# **Division Avenue Road Safety Audit**

Prepared for: Sandpoint, Idaho

December 14, 2020

UT20-2220

Figure 8  $\not{\sim}$

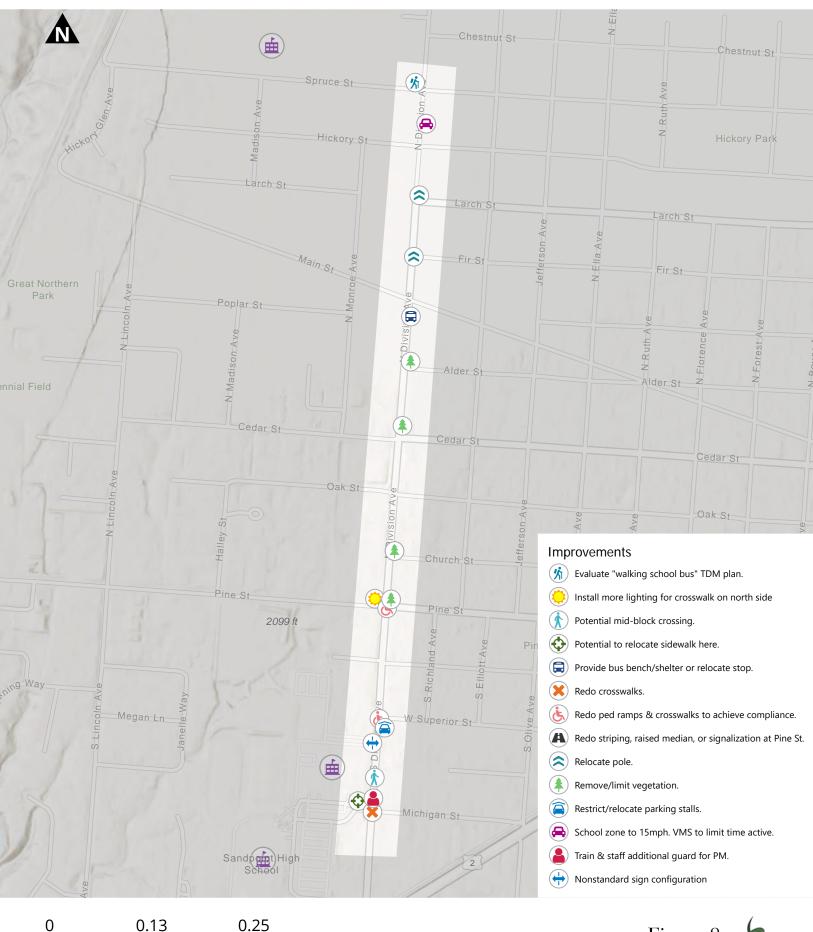
**Figure 8** outlines the easy/short-term and medium/medium-term improvements recommended along the RSA study area.

#### Recommendation 1: Coordinate with Lake Pend Oreille School District to Implement Walking School Bus for Elementary School

#### **Recommendation 2: Implement Crossing Guard During School Closing Peak Period**

#### **Recommendation 3: Add East-West Crosswalk at Fir Street**

#### **Recommendation 4: Increase School Zone Sign Visibility, Limit Restrict Time Active**

#### **Recommendation 5: Reconfigure Northbound Approach at Division Avenue & Pine Street**

#### **Recommendation 6: Perform a Lighting Inventory and Add Lighting as Needed**

#### **Recommendation 7: Remove or Restrict Vegetation in Problem Areas**

#### **Recommendation 8: Relocate or Replace Driveway Signs North of High School**

#### **Recommendation 9: Redo the pedestrian ramps**

#### **Recommendation 10: Provide Bus Benches or Bus Shelters at Bus Stops**

#### Recommendation 11: Relocate the Power Poles in the Sidewalk at Division Avenue & Fir Street and at Division Avenue & Larch Street

Figure 9: Proposed Division Avenue cross section near intersections.

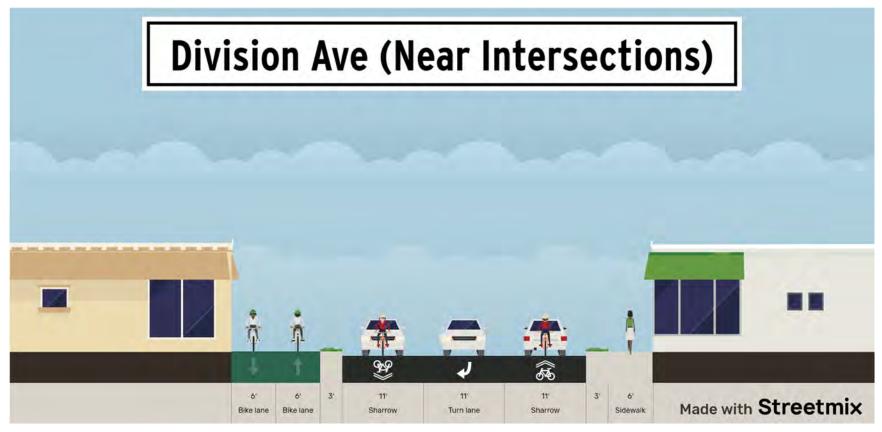
To better serve cyclists, pedestrians, and vehicle traffic along Division Avenue, Fehr & Peers recommends reconfiguring the full length of Division Avenue. Fehr & Peers measured the cross section of Division Avenue at multiple locations and found the average cross section to be about 57 feet across. Sandpoint Public Works staff indicated that maintaining the multi-use path was essential. For bi-directional travel, the multi-use path should be expanded to be at a minimum 10 feet wide. The Public Works staff also indicated that landscaped buffers should be included in any reconfiguration to provide space for snow storage during the winter and to serve as a buffer between cyclists, pedestrians, and vehicle traffic. Since Division Avenue is a designated truck route, Fehr & Peers also recommends maintaining at least 11 feet lanes throughout the corridor.

**Figure 9** shows the cross section of Division Avenue near intersections where a left-turn lane is required. In these segments, the bike lanes are recommended to be removed and the vehicle lanes are recommended to be narrowed to 11 feet to accommodate the widened multi-use path, planting strips, and sidewalk. Since bike lanes would no longer be provided along Division Avenue, Fehr & Peers recommends adding "Sharrow" pavement markings to indicate to drivers that cyclists may use the vehicle travel lane. The sharrows will provide an area for the commuting cyclists while the multi-use path provides an area for the other users who are less comfortable sharing the road with motor vehicles. With the additional space, Fehr & Peers recommended to be widened to 6 feet for the length of the corridor. Planting strips are also recommended to be added to provide snow storage. While Sandpoint City staff expressed that planting strips should be 5 feet wide, due to the limited cross-section space, staff also expressed that a minimum planting strip width of 3 feet would be acceptable near intersections with left-turn lanes.

Figure 10: Proposed Division Avenue cross section mid-block (away from intersections).

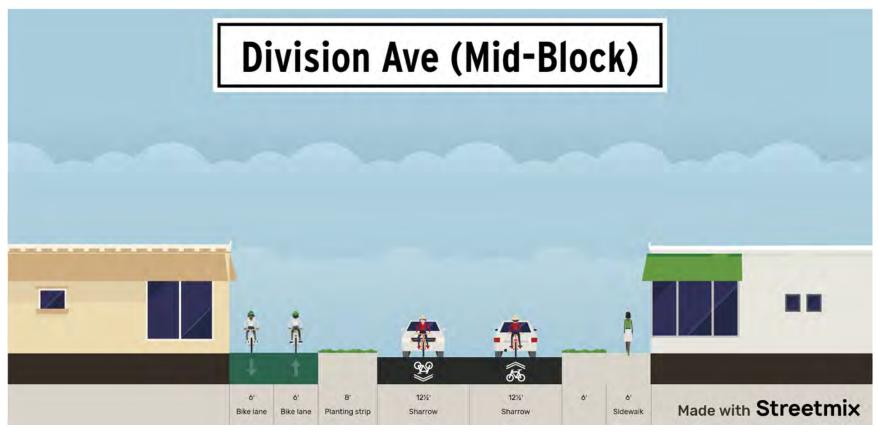
- 1. The wider, directionally marked, multi-use path would provide additional space to cyclists and pedestrians.
- 2. The current 5 feet sidewalk is restrictive for pedestrians with disabilities. Widening to 6 feet provides additional space to make the sidewalk more comfortable.
- 3. The planting strips between the multi-use path/sidewalk and the vehicle travel lanes serve as snow storage and as additional buffer space between bikes/peds and vehicle traffic.
- 4. Historically, wide vehicle travel lanes, like the current lanes along Division Avenue encourage speeding. Narrowing the lanes along Division Avenue is recommended to discourage speeding.

**Figure 10** shows the cross section of Division Avenue between intersections where no left-turn lane is required. In these segments, the 11 feet turn lane is removed and the planting strips are recommended to be widened to provide additional snow storage. The travel lanes are also widened to 12 feet with an extra 0.5 foot added to the gutter, also for snow storage. The multi-use path and sidewalk widths are also recommended to be maintained to provide a continuous walking/biking trail.
